# UNITED STATES PATENT AND TRADEMARK OFFICE

APPLICATION NO.	FILING DATE	FIRST NAMED INVENTOR	ATTORNEY DOCKET NO.	CONFIRMATION NO.
10/018,596	03/14/2002	Gerhard Rinninger	15028	8380

**Office Action Summary**

## DETAILED ACTION

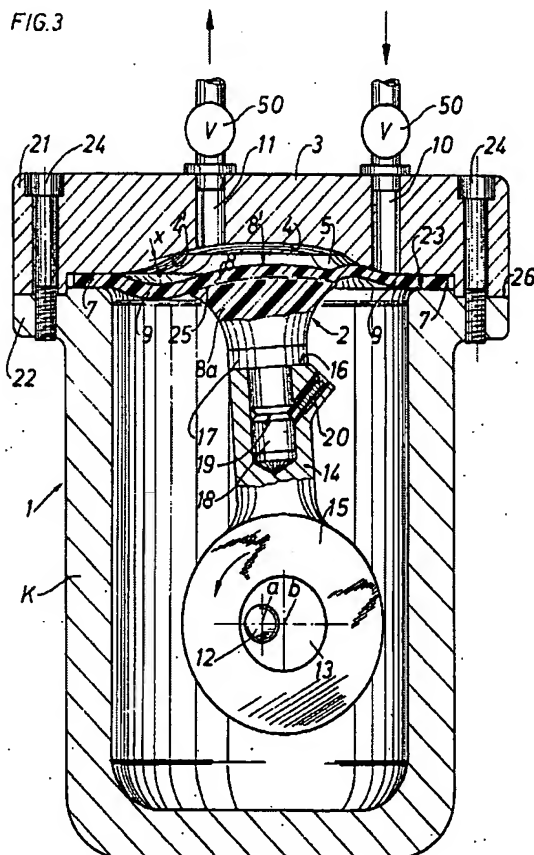
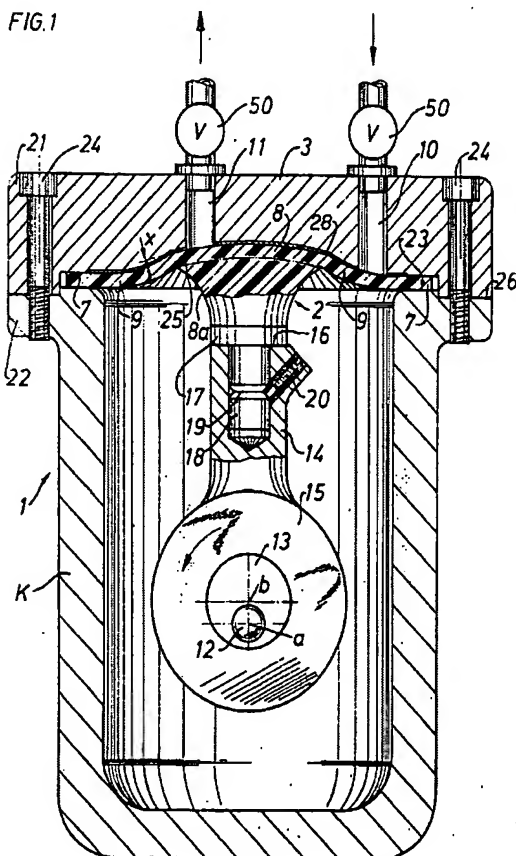
7. With respect to claim 10, **Becker** teaches a pump having a membrane 2 actuated by a crank drive, said membrane 2 bounds together with a concave pump body surface 4, a pump chamber 5, an inlet channel 10 and an outlet channel 11 which open out at an inlet opening and an outlet opening in the pump body surface 4, the membrane 2 having a membrane core 8a and an elastically deformable membrane ring 8 and the membrane core 8a having a convex surface adapted to the pump body surface 4, whereby the inlet opening is arranged in a region of the pump body surface 4 which the membrane 2 first approaches upon an expulsion stroke of the crank drive and the elastically deformable membrane ring 8 closes the inlet opening before the attainment of top dead center of the crank drive, wherein an inlet valve 50 is provided which is arranged in the region of the inlet opening of the inlet channel 10. See particularly **Figures 1, 3.**

8. With respect to claim 12, **Becker** teaches that the inlet opening has a surrounding edge (area surrounding the inlet opening) against which the elastically deformable membrane closes the inlet valve. See particularly **Figures 1, 3.**

9. With respect to claim 13, **Becker** teaches that the middle point of the inlet opening I lies at least approximately in the plane of rotation of the crank of the crank drive. See particularly **Figures 1, 3.**

10. With respect to claim 14, **Becker** teaches that the elastically deformable membrane ring 8 closes the inlet opening at a crank rotary position of the crank drive which is up to 90 degrees before top dead center. Notice that **Figure 1** is the TDC position while **Figure 3** is 90 degrees before TDC. To see this, refer to the location of the axes **a** and **b** corresponding to elements 12 and 13 respectively. As you can see from **Figure 3**, axis **a** and **b** are 90 degrees before TDC. See particularly **Figures 1, 3** and compare the location of elements **a** and **b**.

11. With respect to claim 15, **Becker** teaches that the elastically deformable membrane ring 8 closes the inlet opening at a crank rotary position of the crank drive which is 20 degrees to 90 degrees before top dead center. See particularly **Figures 1, 3** and compare the location of elements a and b.

12. With respect to claim 16, **Becker** teaches that the middle axis of the inlet channel 10 is orientated perpendicularly to the pump body surface 4. See particularly **Figures 1, 3**.

13. With respect to claim 17, **Becker** teaches that the outlet opening of the outlet channel 11 is arranged in a region of the pump body surface 4 which the membrane 2 approaches last and which is attained by the membrane 2 at the earliest at top dead center of the crank drive. See particularly **Figures 1, 3**.

14. With respect to claim 18, **Becker** teaches that the middle point of the outlet opening of the outlet channel 11 is arranged in an inner region of the pump body surface 4 which lies opposite to the membrane core 8a of the membrane 2. See particularly **Figures 1, 3**.

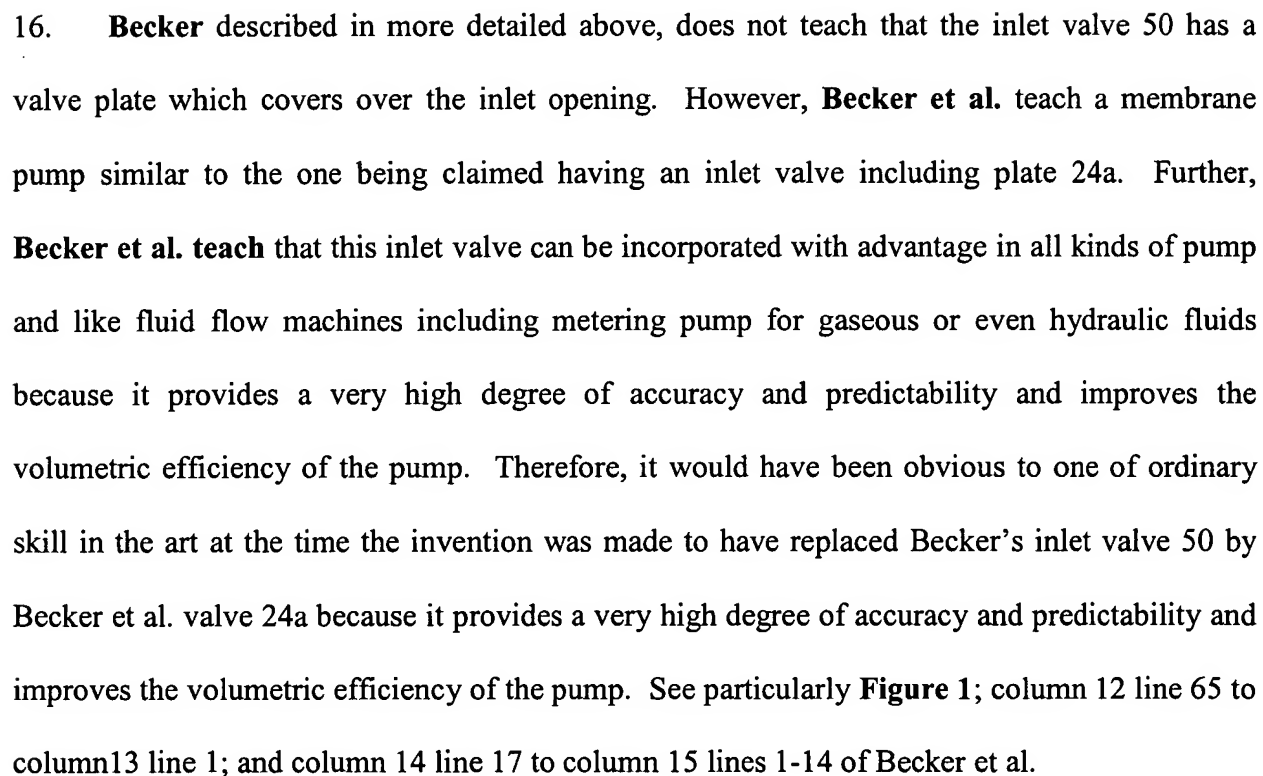
15. Claim 11 is rejected under 35 U.S.C. 103(a) as being unpatentable over **Becker (U.S. 3,947,156)** in view of **Becker et al. (U.S. 5,275,541)**.
